DESCRIPTIVE REPORT

Field No. LJ-10-3-62 Office No. H-8659

Locality Cholmondeley Sound

HYDROGRAPHIC SURVEY REVIEW

1st Ed., June 19/67
8083
1:40,000

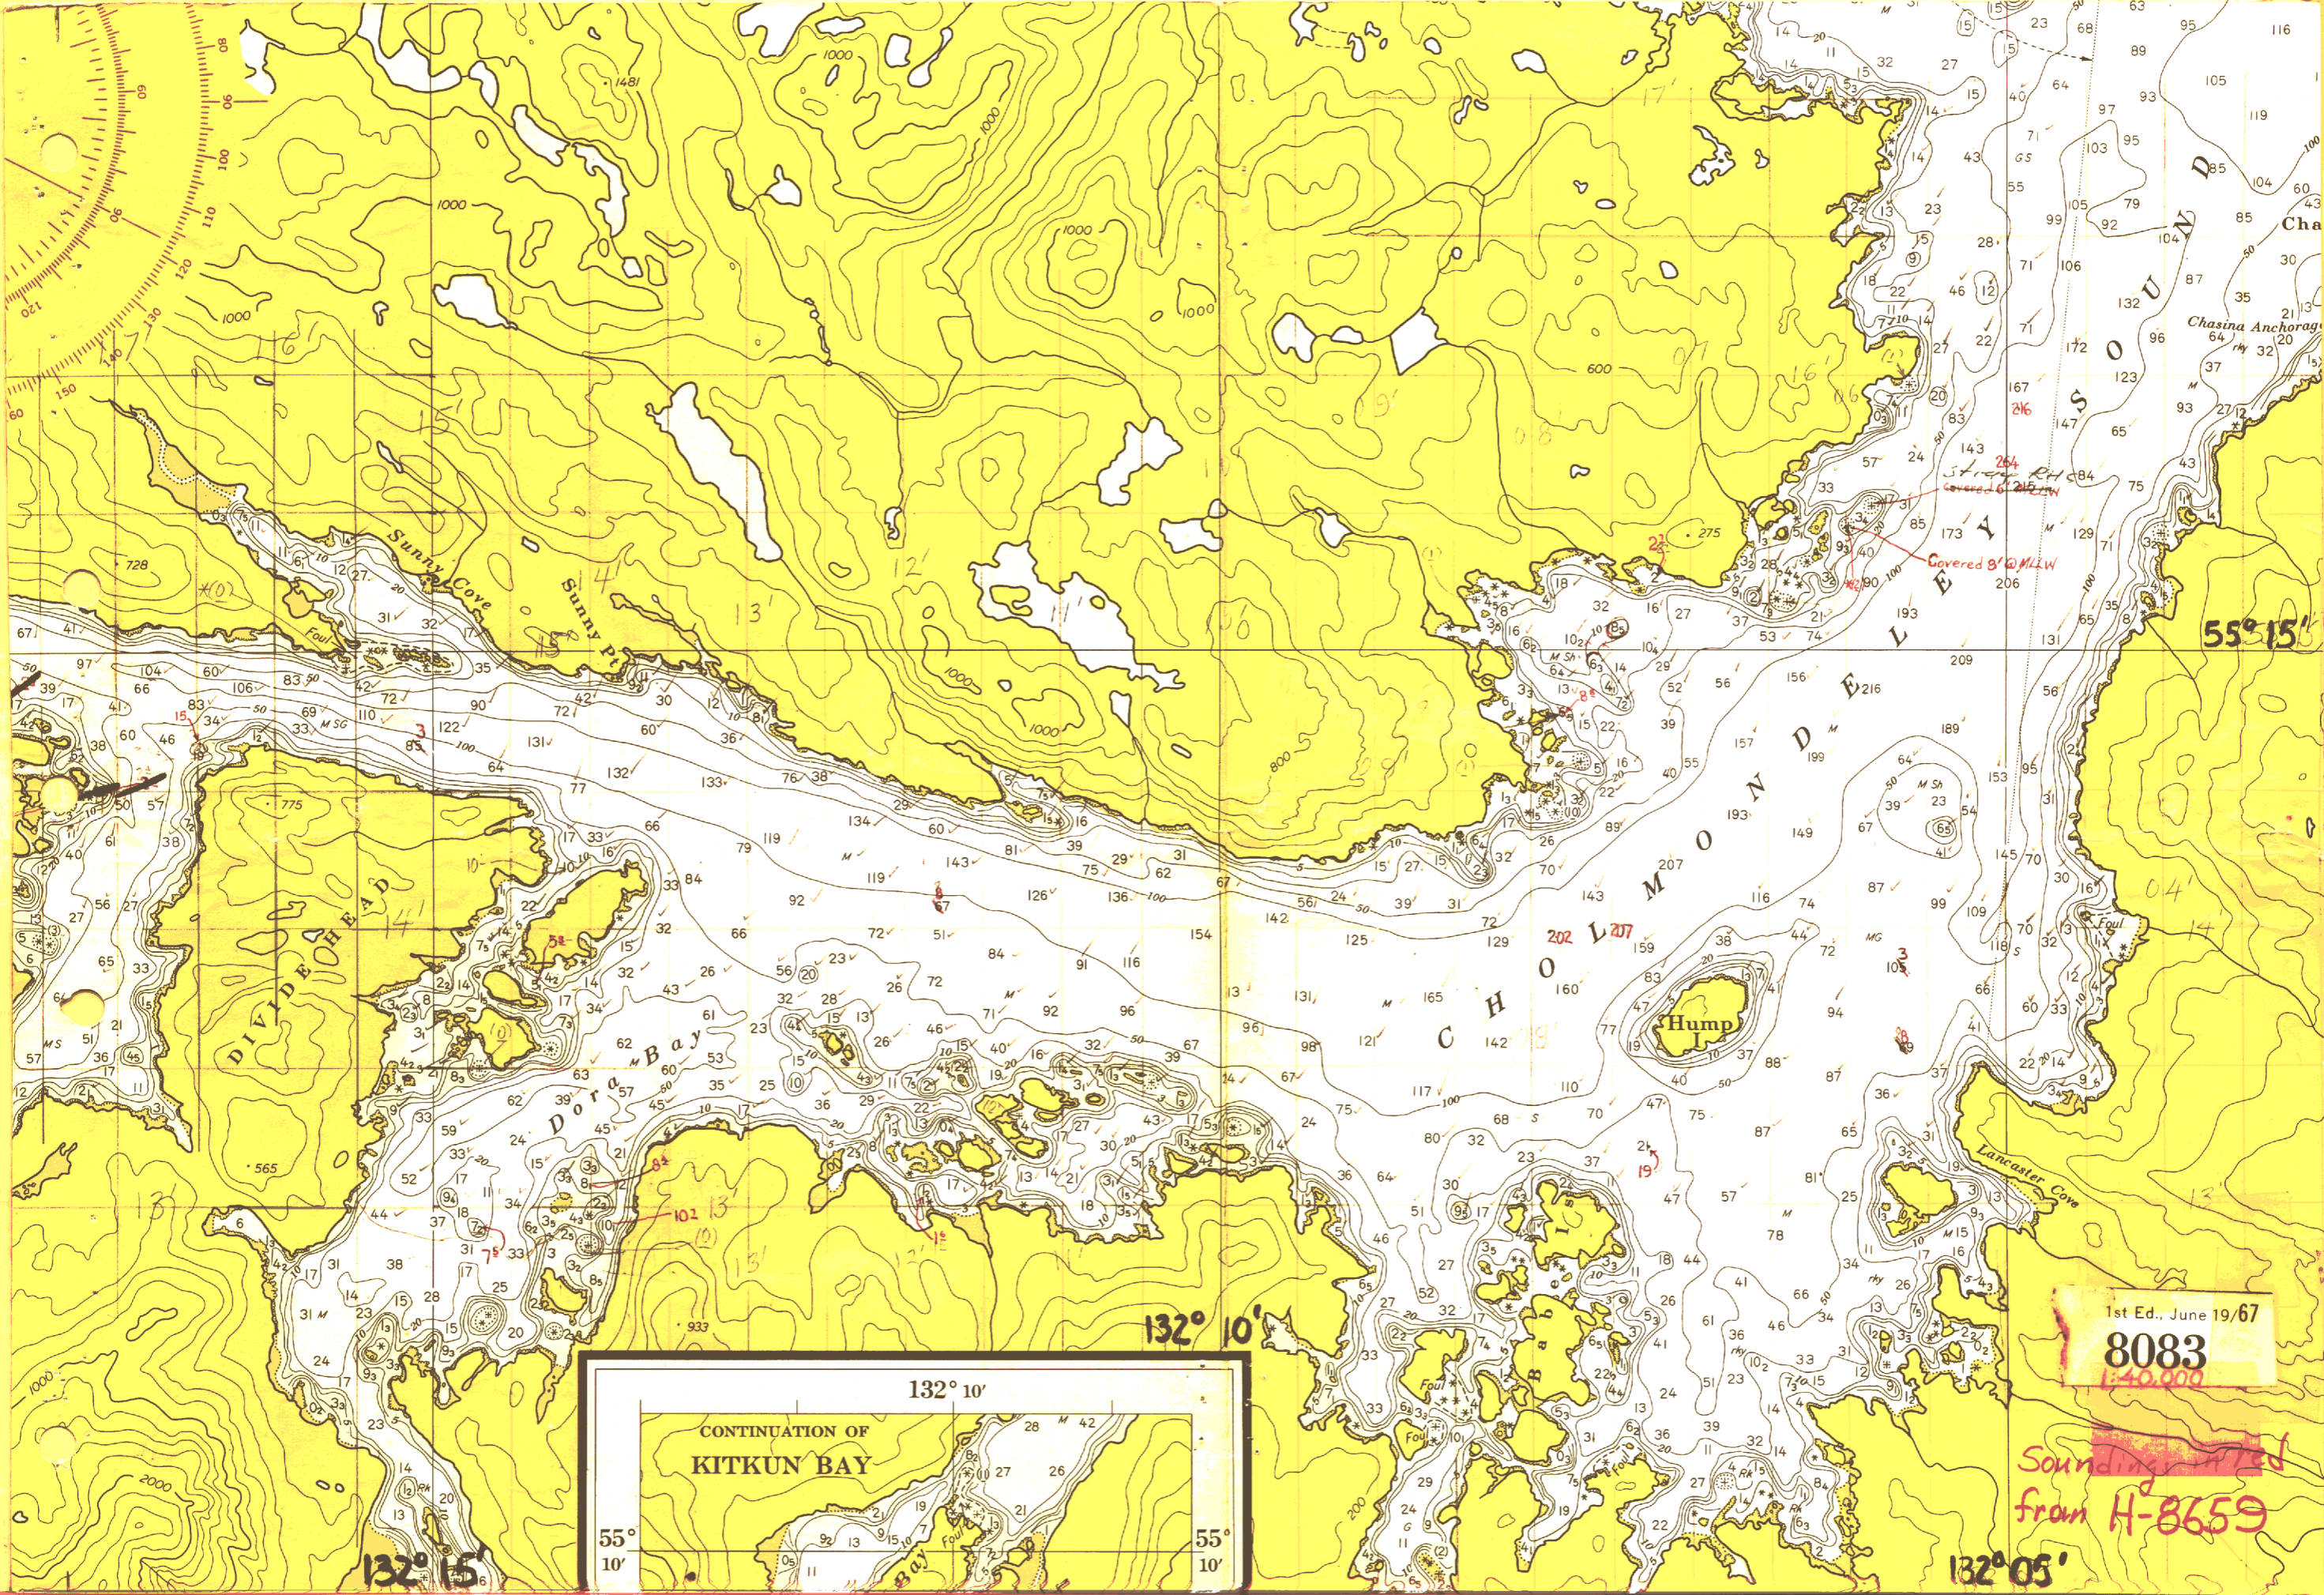
Since writing this addendum this survey has been compared with Chart 8083 1st Ed., June 19/67. A section of the chart is attached which shows differences between smooth sheet and chart in red ink. *gaw*

*Sounding corrected
from H-8659*

Chart - 8102

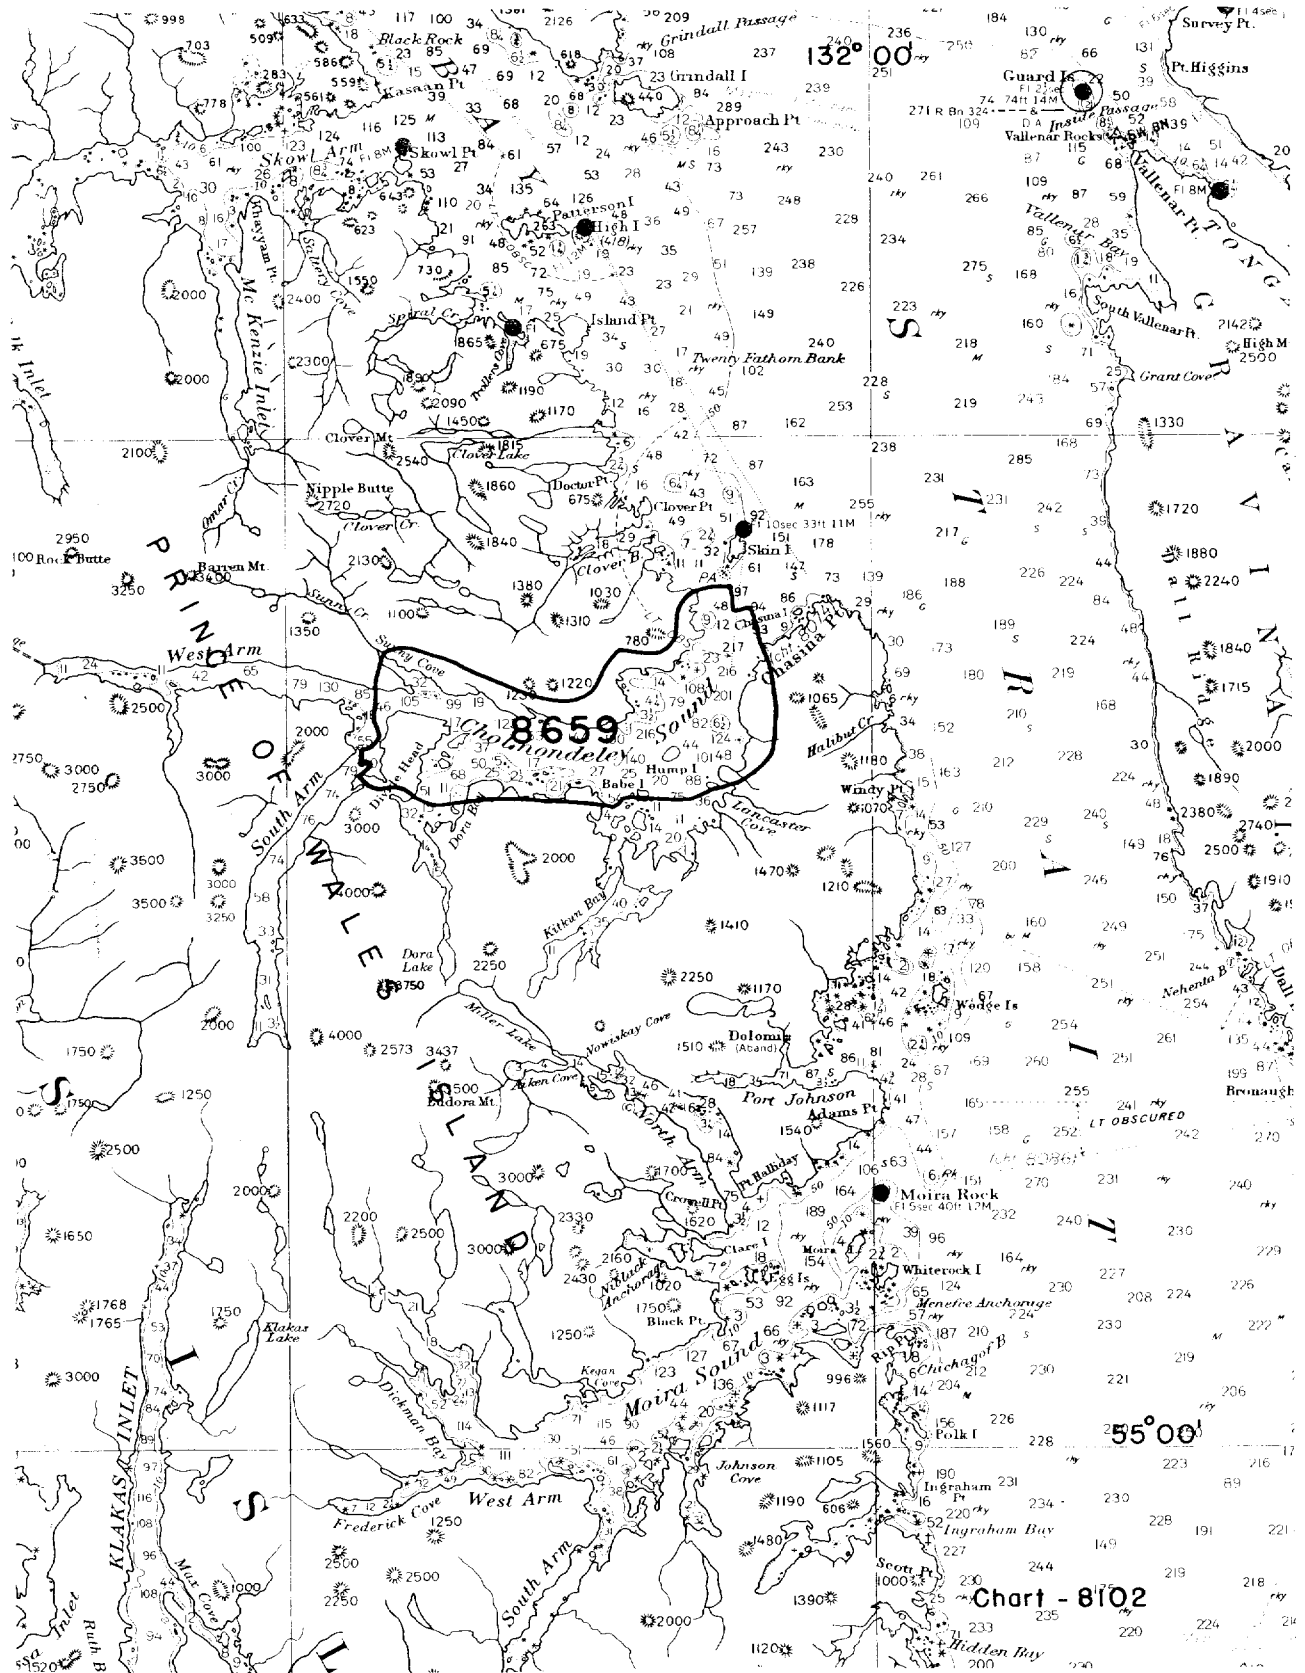
Comparison has been made with Chart 8102, 8th Ed., Dec. 30/65. Differences between the chart and the smooth sheet are shown in red on the chart section enclosed. (See below) ✓
